# STORM WATER MANAGEMENT SUMMARY

PREPARED FOR:  
**DAYTON FREIGHT**  
6450 POE AVENUE, SUITE 311  
DAYTON, OHIO

**APPROVED**  
NOV 15 2016  
VANDERBURGH COUNTY  
DRAINAGE BOARD

11160 GREEN RIVER ROAD  
EVANSVILLE, INDIANA

C300 Grading Plan — Revised sheet C301

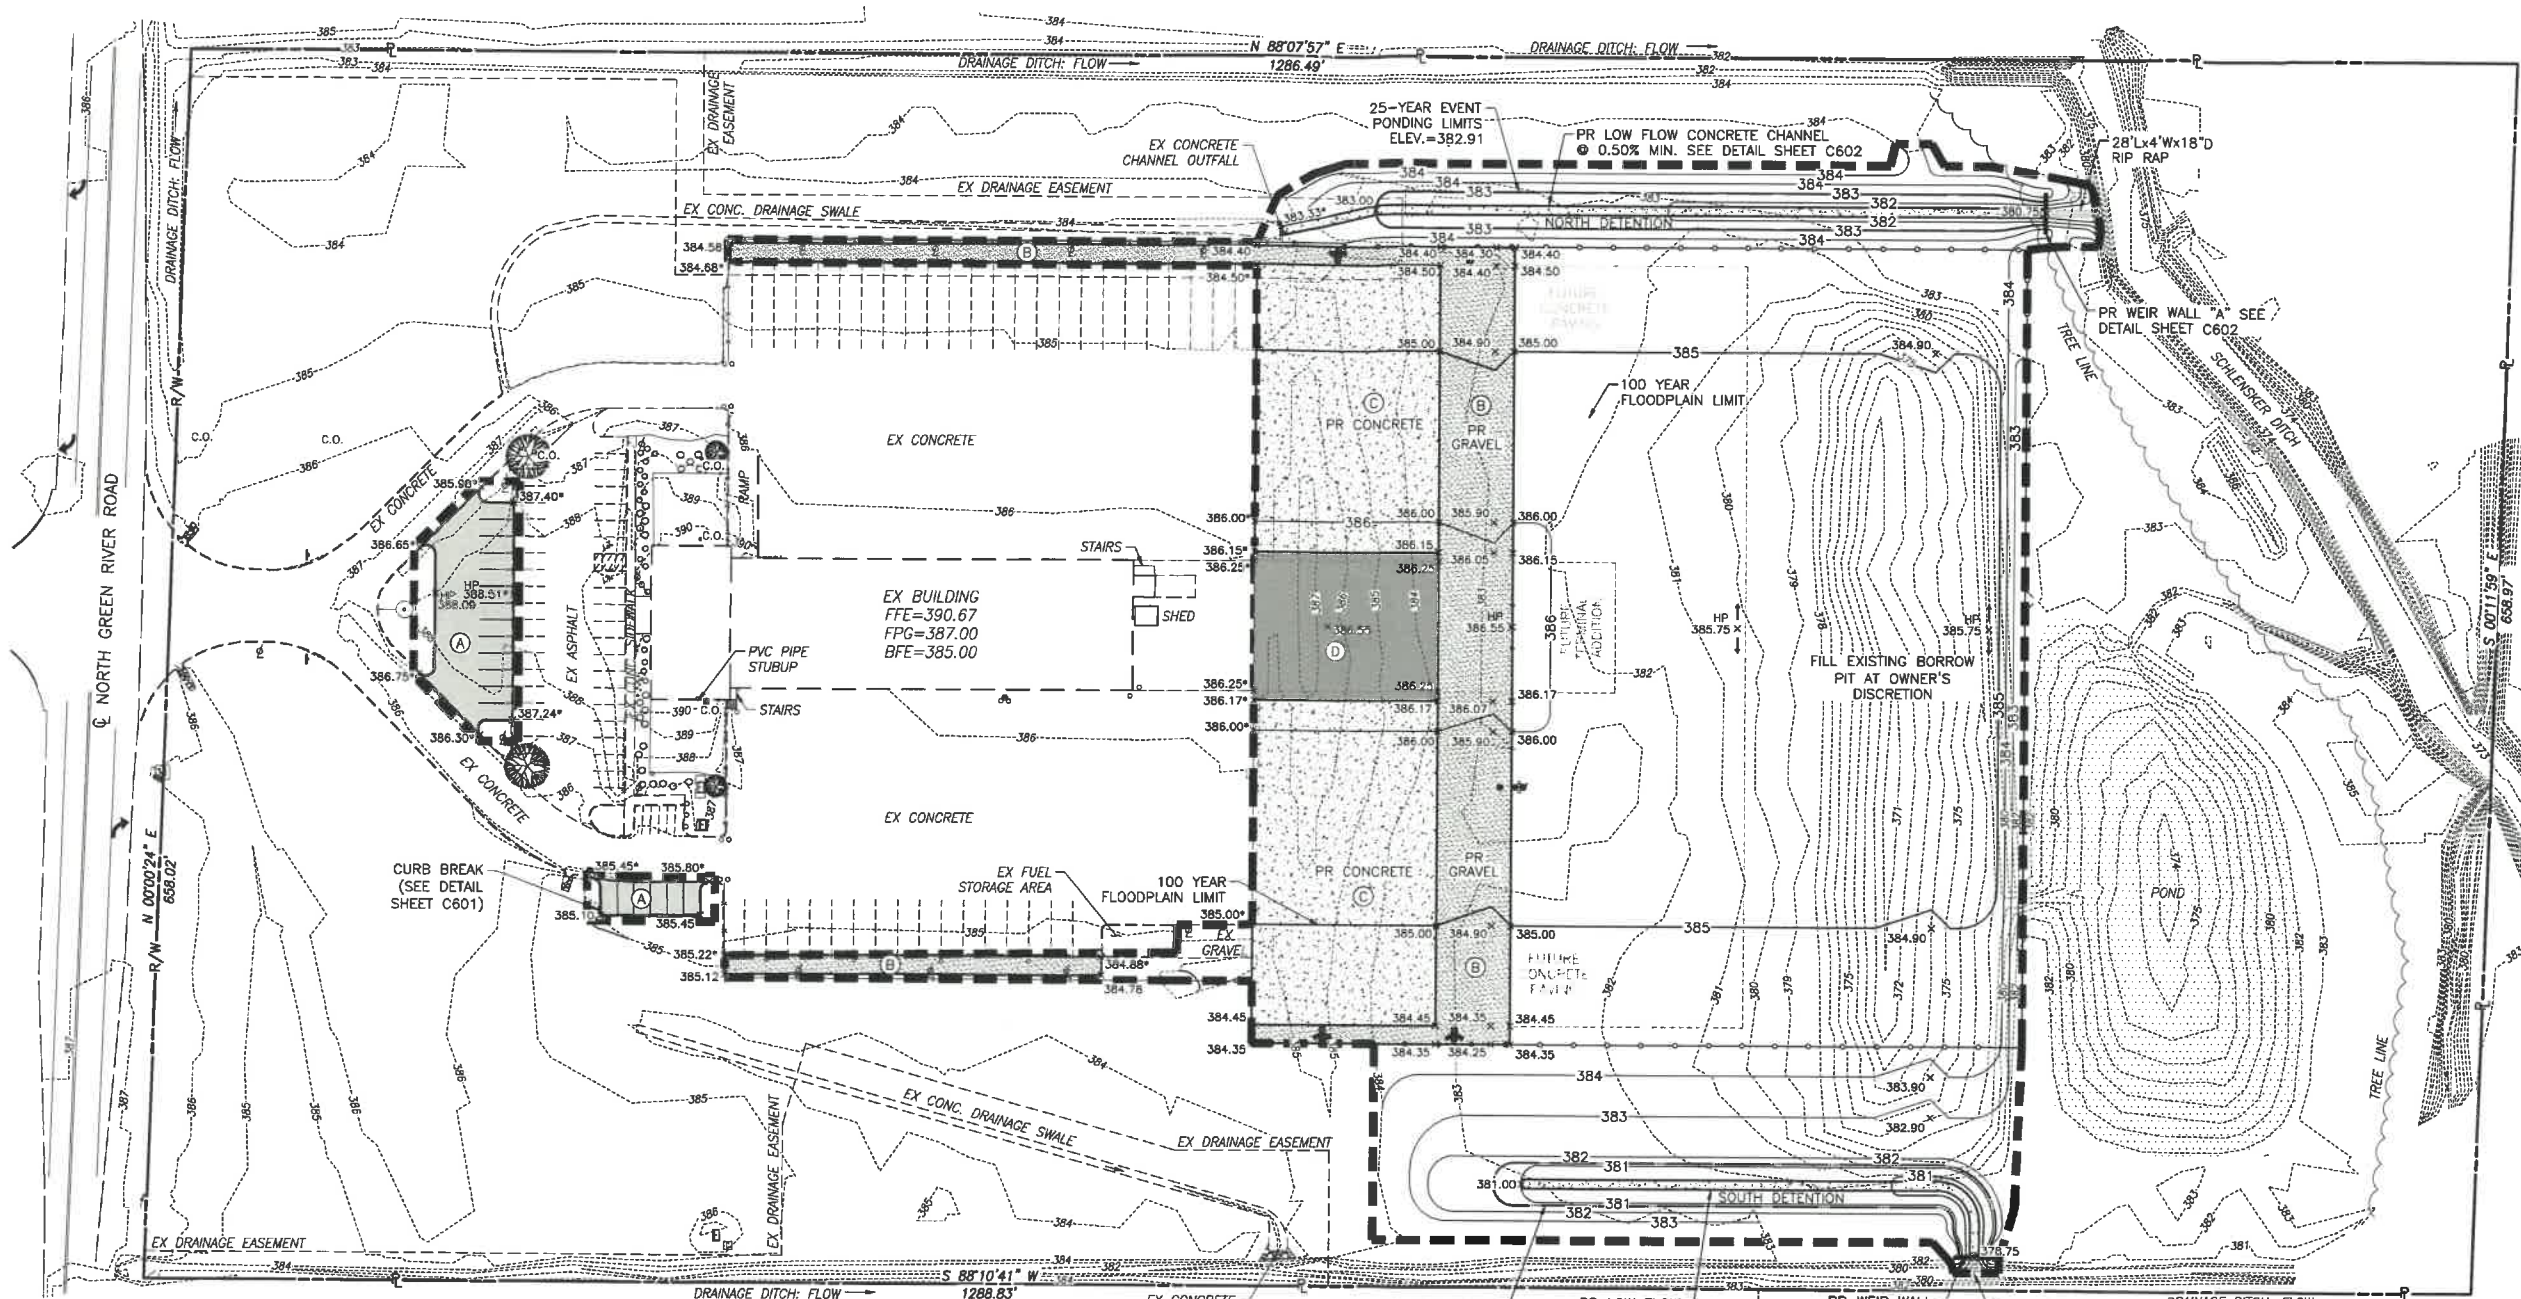
6. BUILDING FINISHED FLOOR ELEVATION TO BE VERIFIED. SURVEYED INFORMATION SHOWED CONSISTENT BASE OF DOCK ELEVATION OF 386.25. DESIGN MATCHES SURVEYED INFORMATION. FFE SHOWN ON THIS PLAN IS FROM ORIGINAL DESIGN PLANS.

POST DEVELOPED  
 CONDITIONS

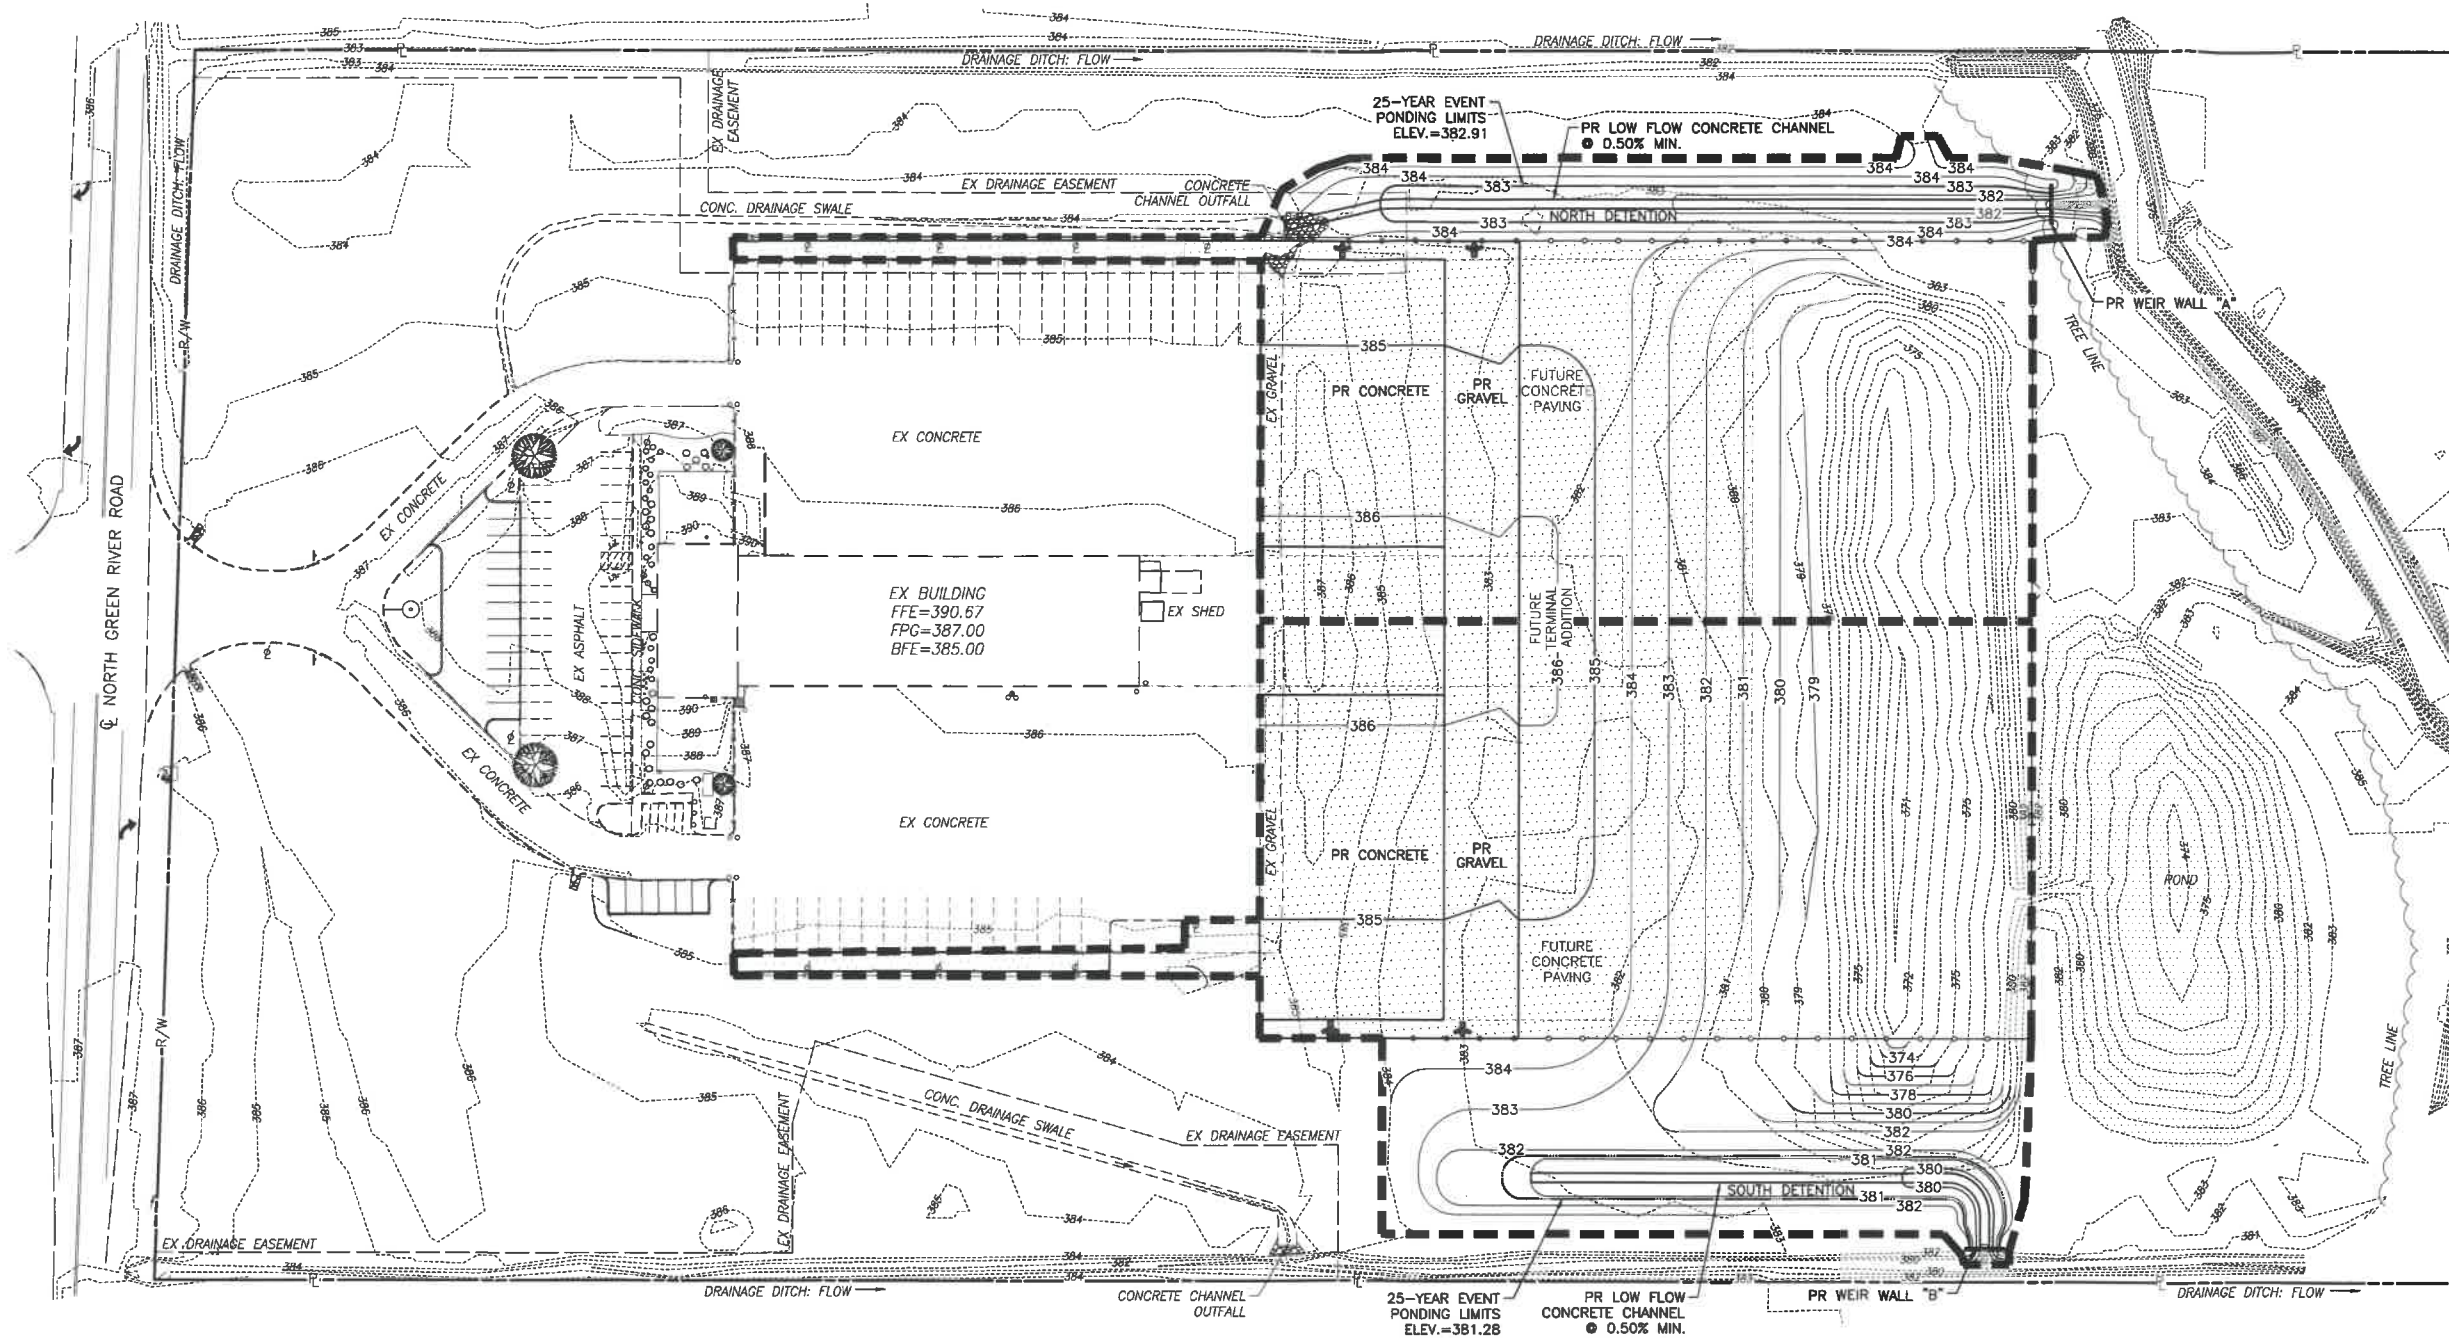
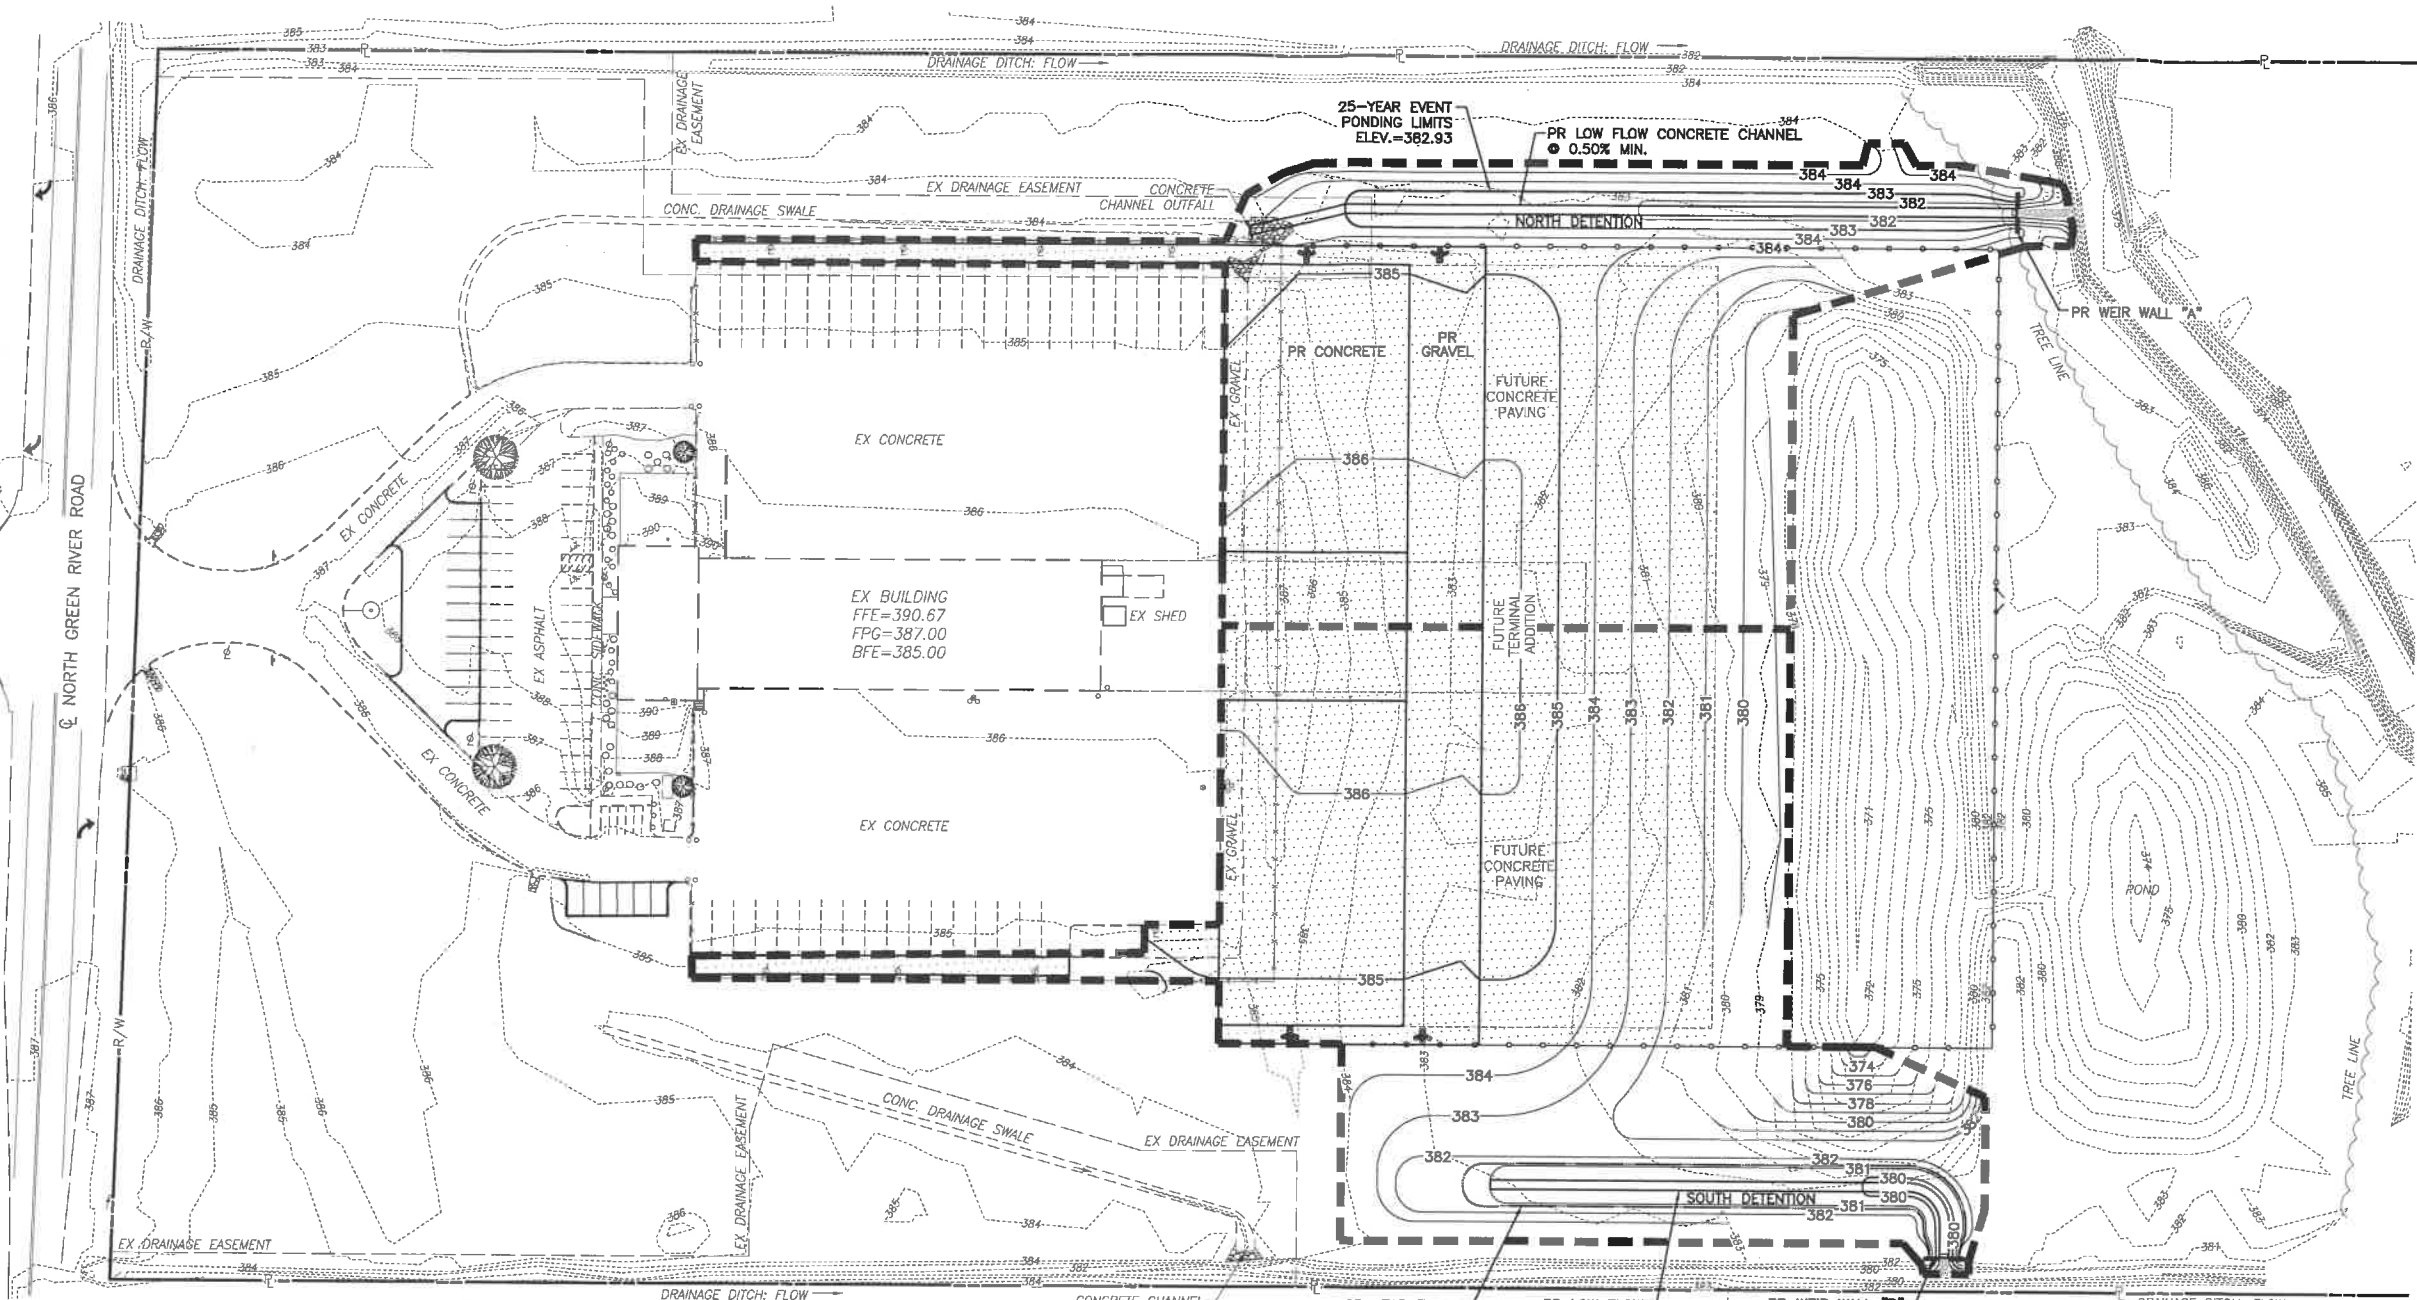
Revised

NORTH AREA	
GREENSPACE (C=0.24):	0.706 AC 35.0%
IMPERVIOUS (C=0.94):	1.312 AC 65.0%
TOTAL	2.018 AC 100.0%

SOUTH AREA	
GREENSPACE (C=0.24):	1.074 AC 42.9%
IMPERVIOUS (C=0.94):	1.432 AC 57.1%
TOTAL	2.506 AC 100.0%
